**PLANNED UNIT DEVELOPMENT
& SUBDIVISION STAFF REPORT****Date: August 8, 2013****DEVELOPMENT NAME**

Claremont Hillcrest Subdivision

CONTEMPLATED USE

SITE PLAN

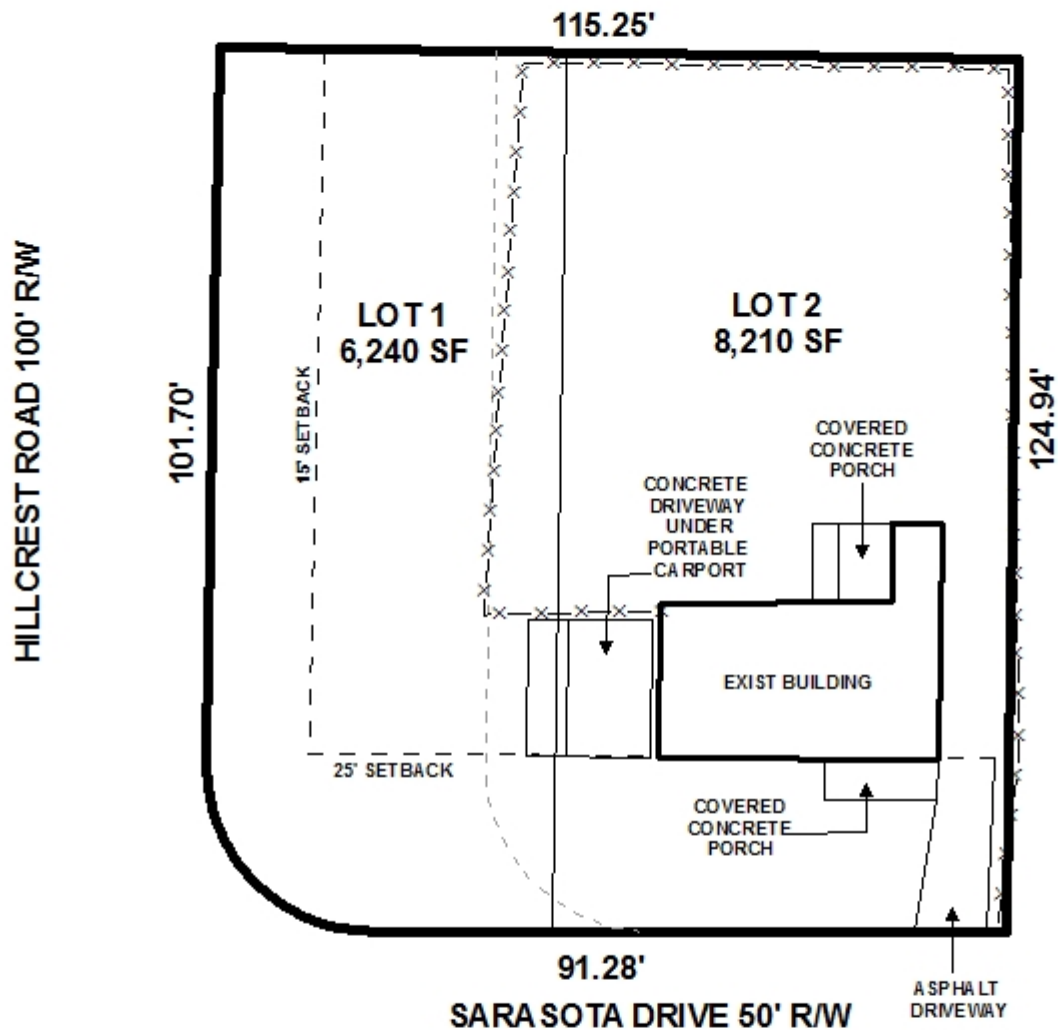
There doesn't appear to be adequate room on LOT 1 to provide a standard residential driveway. An existing power pole and concrete S inlet limits the space available to install a driveway along Sarasota Drive. A driveway to Hillcrest Rd is not recommended. If the Planning Commission approves the Subdivision the following comments should be addressed prior to review, acceptance and signature by the City Engineer: 1) Provide all of the required information on the Final Plat (i.e. signature blocks, signatures, certification statements, legal description, required notes). 2) Provide a signature block and signature from the Traffic Engineering Department. 3) Add a note to the Plat stating that storm water detention will be required for any future addition(s) and/or land disturbing activity in accordance with the Storm Water Management and Flood Control Ordinance (Mobile City Code, Chapter 17, Ordinance #65-007 & #65-045). 4) Add a note to the Plat that any work performed in the existing ROW (right-of-way) such as driveways, sidewalks, utility connections, grading, drainage, irrigation, or landscaping will require a ROW permit from the City of Mobile Engineering Department (208-6070) and must comply with the City of Mobile Right-of-Way Construction and Administration Ordinance (Mobile City Code, Chapter 57, Article VIII). 5) Provide a separate drawing showing the location of a proposed driveway for LOT 1, including, but not limited to, all overhead and underground utilities. This drawing must be approved by the City Engineer and the Traffic Engineer.

Driveway number, size, location and design to be approved by Traffic Engineering, and conform to AASHTO standards. Lot 1 is denied access to Hillcrest Road.

Proposed Lot 2 would contain a compliant 8,210 square feet, but Lot 1 would contain only 6,240 square feet, well short of the 7,200 square feet required by Section V.D.2. of the Subdivision Regulations. And Lot 1 is proposed to be 50' wide which is also in violation of Section V.D.2. of the Subdivision Regulations, which requires residential lots to be at least 60' wide at the building setback line. The plat illustrates the standard 25' minimum building setback line for both proposed lots along Sarasota Drive; however, only a 15' minimum building setback line is proposed for Lot 1 along Hillcrest Road, as opposed to the 25' required by Section V.D.9. of the Subdivision Regulations.

Since no reduction in side or rear setbacks or increased site coverage allowance was requested with the PUD, the site plan and Final Plat should be revised to illustrate the standard 8' side and rear setback lines along the North and East sides of Lot 1, and a note should be placed on the revised site plan and Final Plat stating that Lot 1 is limited to 35% maximum site coverage by all structures. Sidewalks will be required as a part of new construction on Lot 1.

The relocation of the common property line will cause setback, building and fire code issues for the existing carport on Lot 2. The carport should either be removed or relocated, with the appropriate permits. Since the carport is portable, relocating to an appropriate location should not be an issue.

- 1) placement of a note on the Final Plat stating that each lot is limited to one curb cut to Sarasota Drive, with the size, location and design to be approved by Traffic Engineering, and conform to AASHTO standards;*
- 2) placement of a note on the Final Plat stating that Lot 1 is denied access to Hillcrest Road;*
- 3) labeling of each lot with its size in square feet and acres, or the furnishing of a table on the Final Plat providing the same information;*
- 4) placement of a note on the Final Plat stating that development of the site must be undertaken in compliance with all local, state and Federal regulations regarding endangered, threatened or otherwise protected species;*
- 5) subject to the Engineering comments: [There doesn't appear to be adequate room on LOT 1 to provide a standard residential driveway. An existing power pole and concrete*

- 1) placement of a note on the site plan stating that each lot is limited to one curb cut to Sarasota Drive, with the size, location and design to be approved by Traffic Engineering, and conform to AASHTO standards;*
- 2) placement of a note on the site plan stating that Lot 1 is denied access to Hillcrest Road;*
- 3) revision of the site plan to illustrate the 8' side and rear setback lines along the North and East sides of Lot 1;*
- 4) placement of a note on the site plan stating that Lot 1 is limited to 35% maximum site coverage by all structures;*
- 5) submittal of two (2) copies of a revised site plan to the Planning Section of Urban Development prior to signing of the Final Plat; and*
- 6) compliance with all other municipal codes and ordinances.*
